Technical Bulletin

DP02	TB0030-2008	Elan Motorsports Technologies	
From:	Brian Frankum		
Subject:	<i>Tunnel Floor Capping Strips & Front Skid</i>	Date:	July 22 nd , 2008

Figure 1: Optional skid components

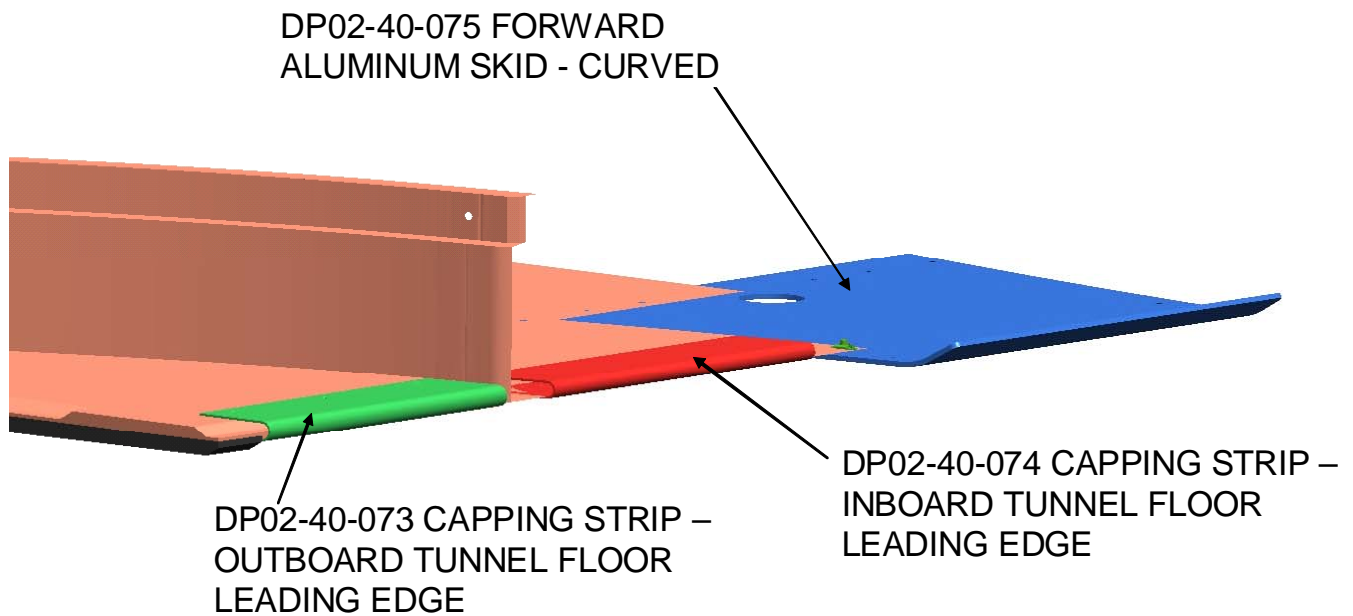
An optional front skid plate (DP02-40-075) is available for purchase. In addition, capping strips are available for the inboard (DP02-40-074) and outboard (DP02-40-073) leading edge of the tunnel floors. Quantity 2 each, of the capping strips, are needed for a car set. They may be attached to the floors using 1/8" countersunk blind rivets.
